**TRANSMITTAL OF CORE OPERATING LIMITS REPORT**

**H. B. ROBINSON STEAM ELECTRIC PLANT (HBRSEP), UNIT NO. 2**  
**CYCLE 30 CORE OPERATING LIMITS REPORT, REVISION 0**

**SUMMARY OF CHANGES**  
**PRR 725866, EC 94784**  
**FMP-001 Revision 31**

Figure 1.0, Control Group Insertion Limits for Three Loop Operation

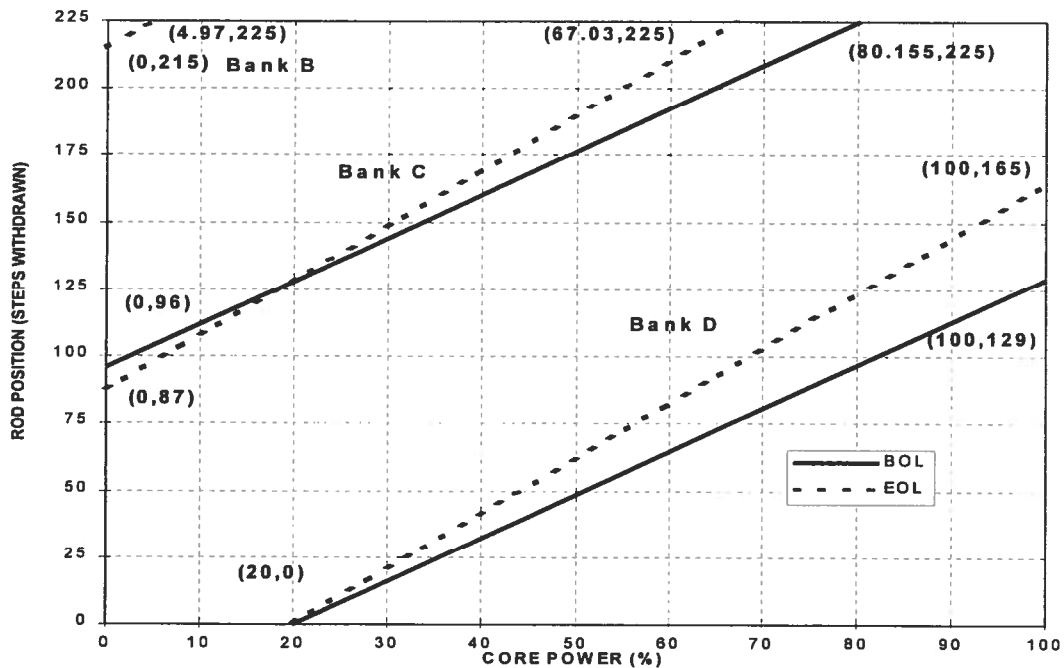
| Section/Step                                     | REVISION COMMENTS   |
|--|---|
| Attachment 10.1 Step Figure 1.0                  | Update the breakpoint burnup in the note of Figure 1.0 from 273 EFPDs (9,500 MWD/MTU) to 305 EFPDs (10,600 MWd/MTU) |

**NOTE:** The breakpoint between BOL and EOL RIL occurs at 50% of the cycle as defined by burnup. For Cycle 30, this burnup occurs at 305 EFPDs (10,600 MWD/MTU).

Figure 3.1 V(z) as a Function of Core Height

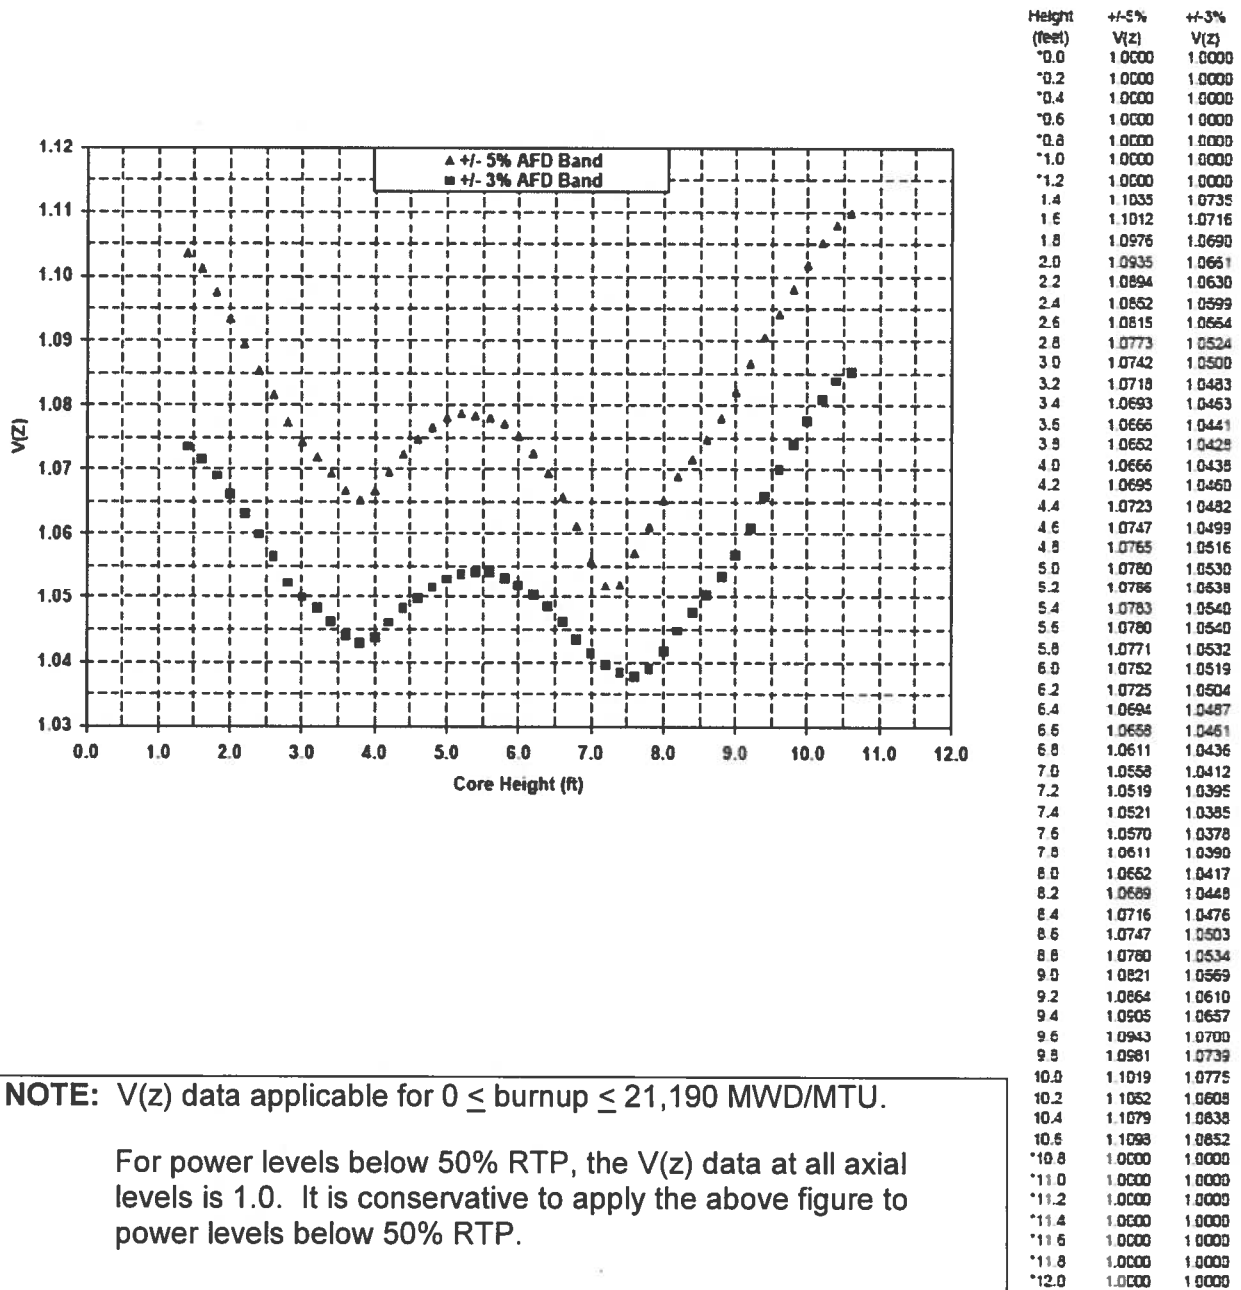
| Section/Step                                     | REVISION COMMENTS   |
|--|---|
| Attachment 10.1 Figure 3.1                       | Updated the V(z) applicability upper burnup from 18,976 MWD/MTU to 21,190 MWD/MTU.                                  |
